PCN#03C-13 supersedes PCN#03B-13
see PCN history for change descriptions.

Subject: PCN# 03C-13 Notification of Intent to Utilize an Alternate Qualified Assembly / Test Site and Alternate Qualified Material Sets for Select Lattice Products

Affected Products

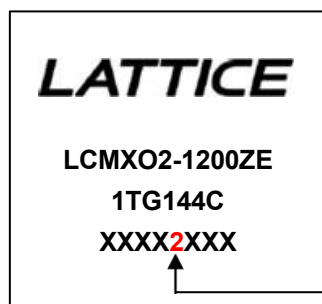
In an effort to expand Copper bond wire (Cu-wire) manufacturing capacity, Lattice will now use Advanced Semiconductor Engineering Kaohsiung, Taiwan (ASET) for select devices. ASET utilizes industry standard raw materials, assembly and test processes. The use of these alternate qualified material sets will not change external package dimensions. The package footprints remain the same and are published on the [Lattice website](#). These changes will not impact form, fit or function.

The Ordering Part Numbers (OPNs) affected by this PCN are listed in an Excel spreadsheet [here](#). This PCN also affects any custom devices (i.e. factory programmed, special test, tape and reel, non-standard speed grade and package, etc.), which are derived from any of the devices listed in the table.
